3.2 15 Scott Street CANTERBURY

15 Scott Street, Canterbury

Application no.:	PP19/0688
Responsible director:	Shiran Wickramasinghe Urban Living
Authorised by:	Simon Mitchell, Manager Strategic & Statutory Planning
Report officer:	Timothy Luckin, Statutory Planner

STATUTORY PLANNING OFFICERS REPORT Urban Planning Delegated Committee

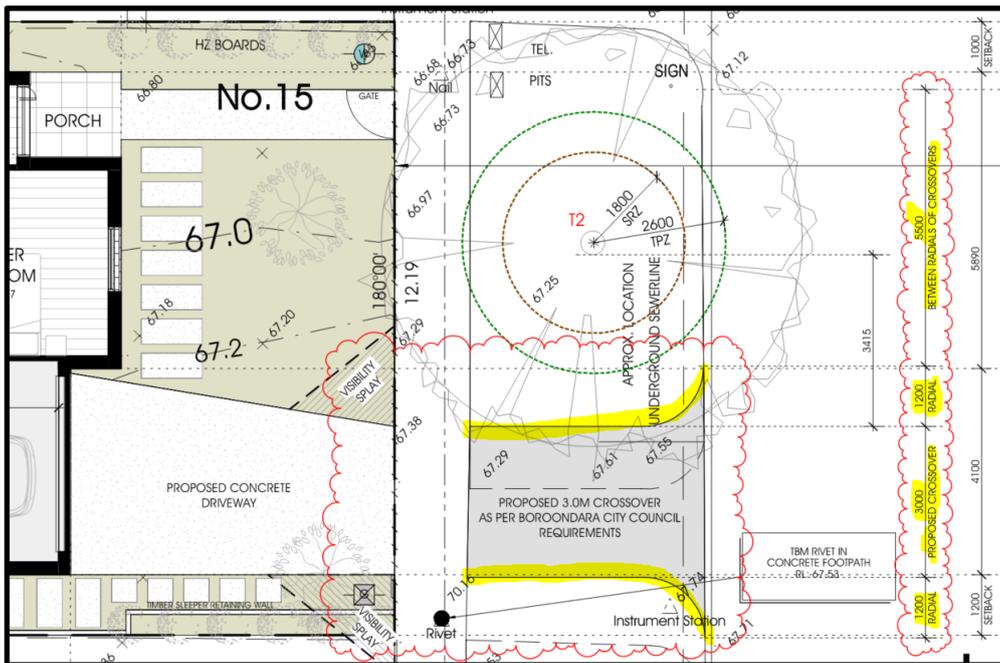
In response to concerns raised by Council’s Infrastructure Department, new plans were submitted to Council on 25 August 2020.

The revised plans show a revised crossover and driveway to meet the requirements of Council’s Infrastructure Department. The crossover and driveway have been reduced in width. The revised crossover is discussed in detail in the ‘Infrastructure’ internal referral section of this report. A screenshot of the revised crossover and driveway is shown below. These plans have are referenced as ‘discussion plans’ in this report.

- a) The following changes as depicted on the 'Discussion Plans' received by Council on 25 August 2020 (TP.03):
 - i) Crossover reduced to 3 metres in width (not including the radial turnouts);

- ii) Crossover with 1.2 metre radial turnouts at the street kerb;
 - iii) A minimum 5.5 metres spacing between the proposed northern crossover radial and the crossover radial for 13 Scott Street; and

- iv) A revised driveway to align with the new crossing location.
 - b) An amended material schedule stating the garage door material will be timber.
 - c) An annotation stating the proposed front fence will be timber picket with at least 25% transparency.

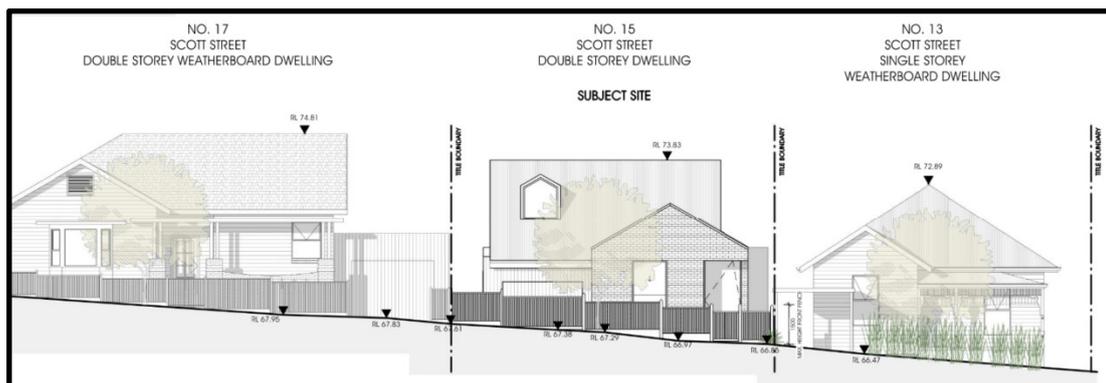
Despite the proposed dwelling being higher than 13 Scott Street, it is important to note that the upper ridge of the proposed dwelling sits behind the ridge of 13 Scott Street (this can be seen in the highlighted screenshot below). Siting the roof further back reduces the prominence of the dwelling.

A screenshot of the streetscape elevation is shown below. The streetscape elevation demonstrates the new dwelling will allow a transition in heights between 17 Scott Street and 13 Scott Street which runs with the fall of the land.

The height of the façade is considered to be in keeping with the prevailing heights of the adjoining 'contributory' graded heritage places.
